# **Teck Coal Limited**

## **Quintette Coal Operations**

### ***2017 Dam Safety Inspection***

### ***Shikano North Tailings Dam***

PROJECT		QUINTETTE COAL OPERATIONS 2017 DAM SAFETY INSPECTION	
TITLE			
SHIKANO NORTH TAILINGS DAM GENERAL ARRANGEMENT			
PROJECT No.	M09684A14	FIG No.	1

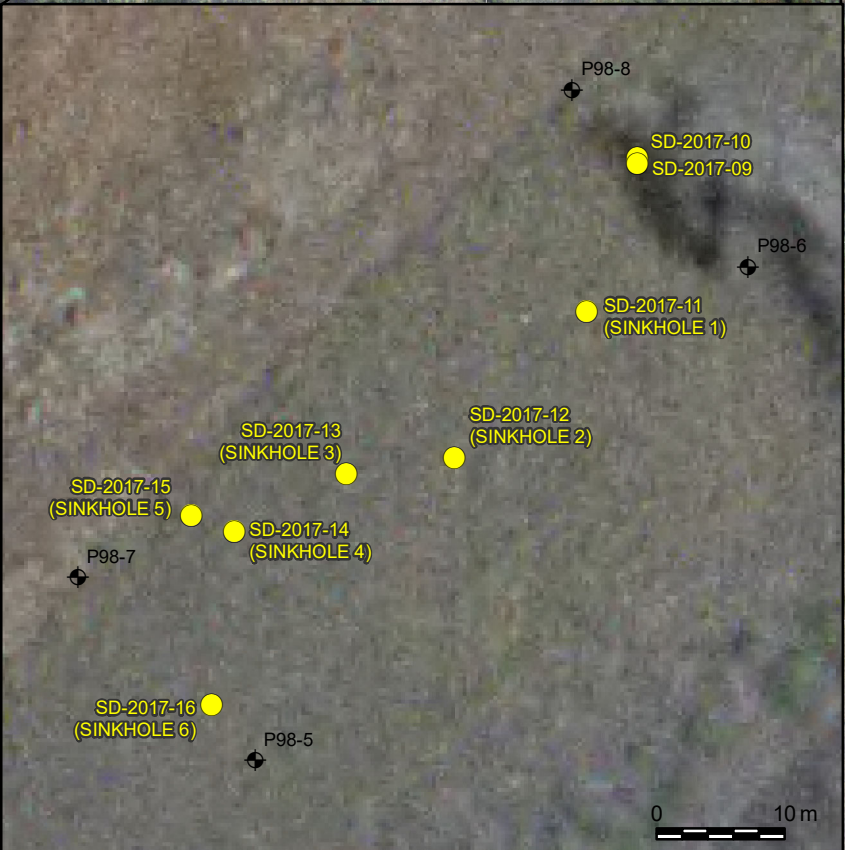
- **Sinkhole Depressions in Tailings Beach (refer for Figure 1 and Photo I-7 for sinkholes general location):** A cluster of sinkholes (Sinkhole 6) were observed on the tailings beach (Photo I-20). The largest of the sinkholes is approximately 7 m by 3.5 m and 2 m deep. These features have been noted since the 2010 DSI but when they started to form is not known. There was a notable increase in size between the 2012 and 2013, and between 2016 and 2017 DSIs but a less significant increase noted between 2014 and 2016. Sinkholes 2 and 3 were observed in 2015 in the tailings beach, which also appears to have slightly increased in size in 2017 (Photos I-16 and I-17). Sinkholes 1 and 9 were observed in 2016 in the tailings beach and only Sinkhole 1 appears to have slightly increased in size in 2017 (Photos I-15 and I-26). Sinkholes 4, 5, 7 and 8 were first observed during the 2017 inspection (Photo I-18, Photos I-19, I-24, and I-25). The cause of these features is most likely the migration of tailings into the upstream coarse rockfill shell and "windows" of high permeability gravel (Figure 2) which are upstream of the filters. Sinkholes are considered a local condition. A sinkhole monitoring program should be established and conducted in conjunction with the routine visual inspections at the SNTD. The sinkholes should be shown on a drawing for future reference.

The monitoring program of the sinkholes should include the installation of stakes or wooden posts along the outside of the sinkholes to determine if there is growth and the rate of the growth (KCB to provide further guidance). Alternatively, an aerial survey or LiDAR may be utilized to capture the development of the sinkholes. Currently the sinkholes are inspected during the annual DSI site visit.

SECTION A  
FIG. 1

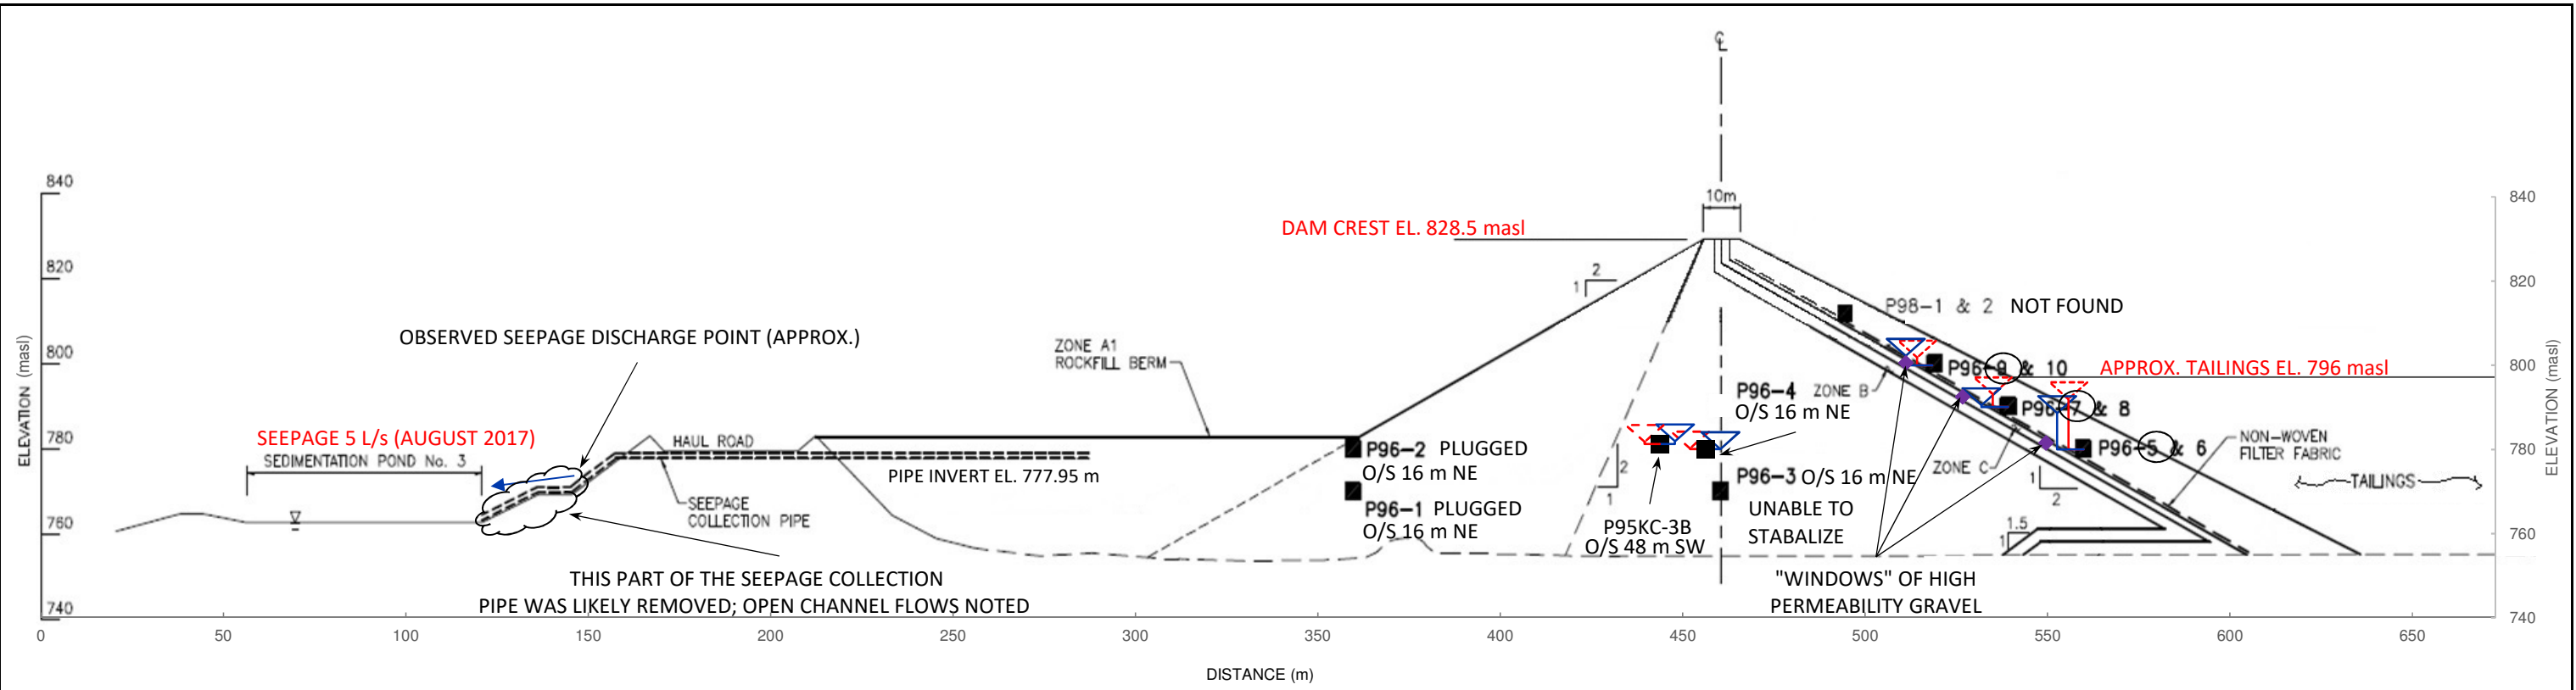
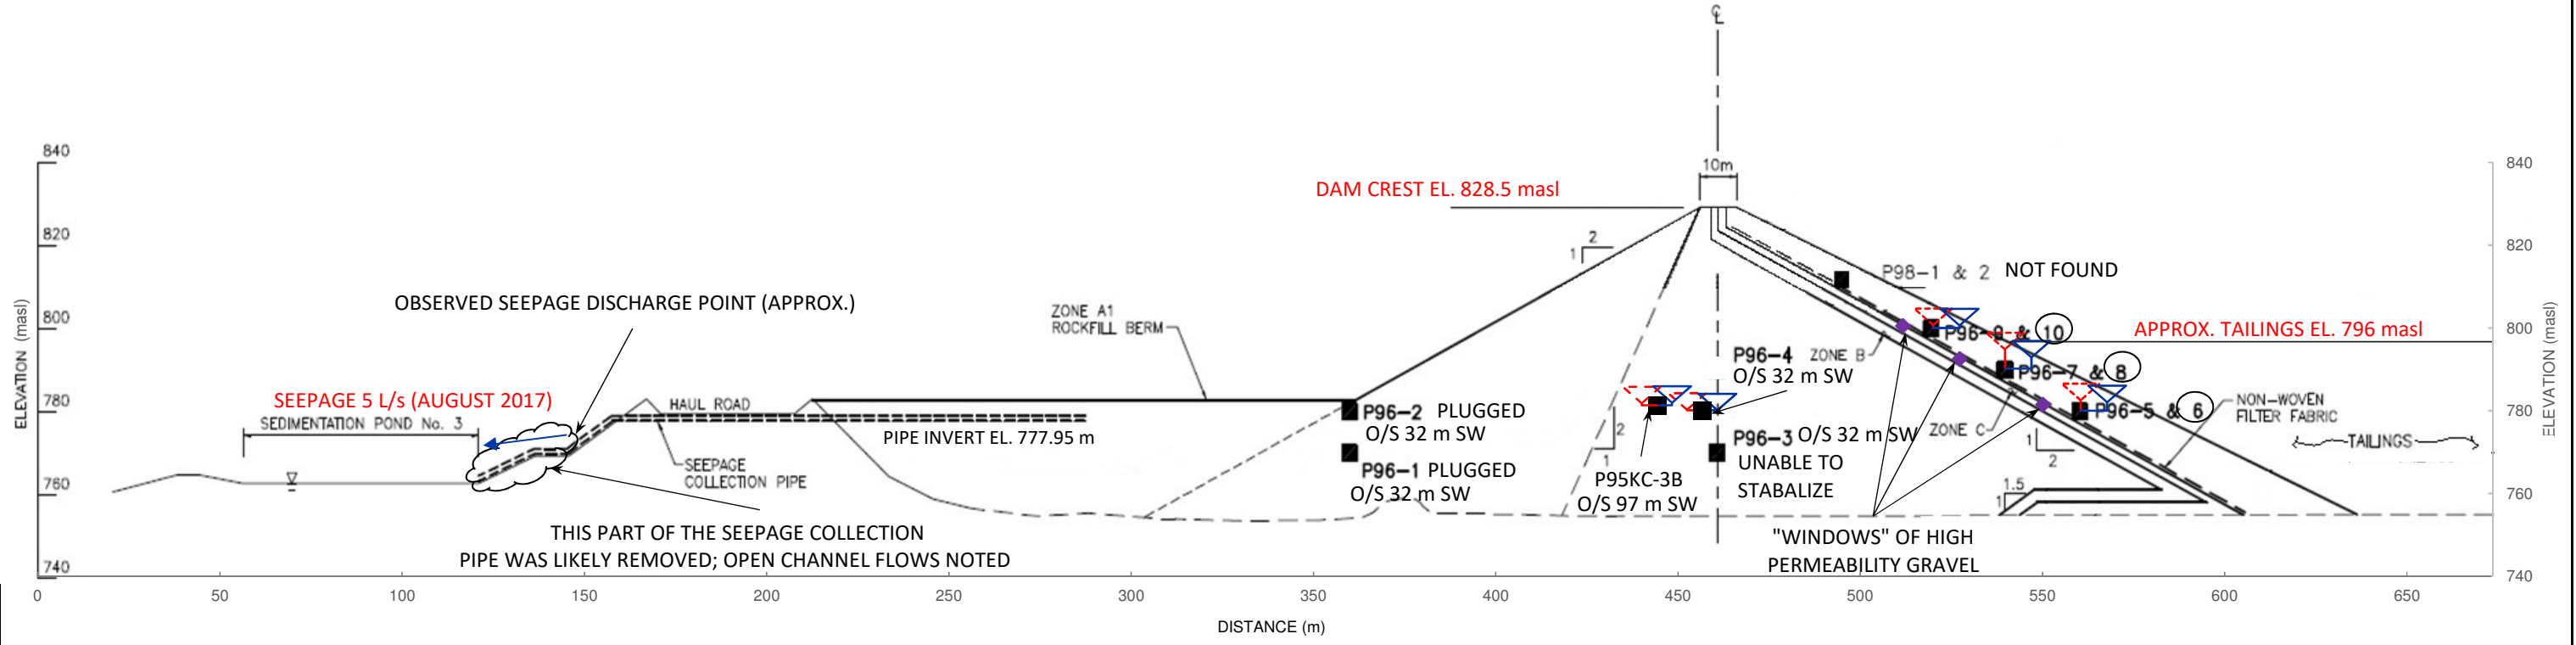
- ◆ P96-4 instrument cable was noted as plugged in KC (1999a) and the instrument continued to give unreasonable reading (+34 psi) in 2017, so it has been disregarded. P96-4 cable was suspected to have been switched with P96-3 in 2016 and in earlier years. P96-3 (before being relabelled to P96-4 in 2017) has been recording approximately 0.1 m of water head above the instrument tip (i.e., El. 770.1 masl), which appears to be lower than the perforated CSP seepage collection pipe (i.e., pipe El. 778 masl as shown in Figure 2). In addition, P96-4 reported tip elevation was incorrectly shown in the as-built drawing D-16003 (Appendix II), which shows the tip elevation at approximately 790 masl instead of installed El. 780.1 masl (KC 1999b). After the revision of P96-4's tip elevation and the labelling between P96-3 and P96-4, the 2017 water elevations recorded by P96-4 were between El. 780.1 m and 780.2 m (Figure 2), which are consistent with the CSP elevation. P96-3 is now being reported as "Unable to Stabilize" (Figure 2).

- ◆ P95KC-3A was not found; Teck managed to find P95KC-3B after it has been reported as "not found" in previous DSI reports. The instrument location and its water levels are shown in Figure 2.

**Photo I-25 Sinkhole 8 – was not observed in 2016. Approximately 0.1 m x 0.2 m x 0.2 m deep (SNTD-2017-18)**

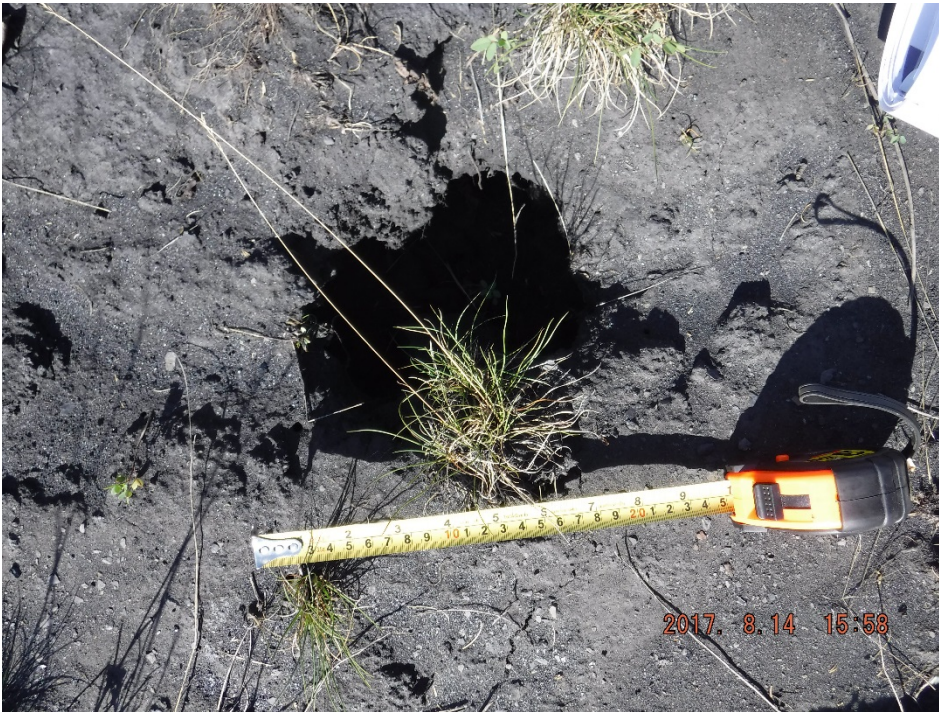
**Photo I-24 Sinkhole 7 – was not observed in 2016. Approximately 0.2 m x 0.2 m x 0.2 m deep (SNTD-2017-17)**

**Photo I-26 Sinkhole 9 – first observed in 2016. Approximately 0.1 m x 0.1 m x 0.1 m deep (SNTD-2017-20)**
